PCN

Automatic production line for EPCOS NTC ICLs in Zhuhai

Product / Process Change Notification

1. ID No.: PPD14/T122		2. Date of announcement: December 1, 2017	
3. Product / product group: EPCOS NTC ICLs	Old ordering code: B57234S* B57237S* B57238S* B57364S*	New ordering code: No change	Customer part number:

Figure: Loop kink design

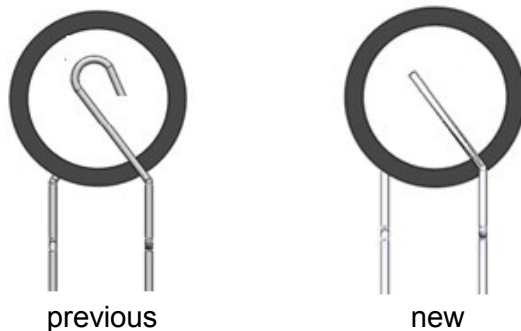
- Automation of wire-forming, soldering, coating, testing, marking and packing production steps.
- Change of the loop kink termination design from bent to straight.
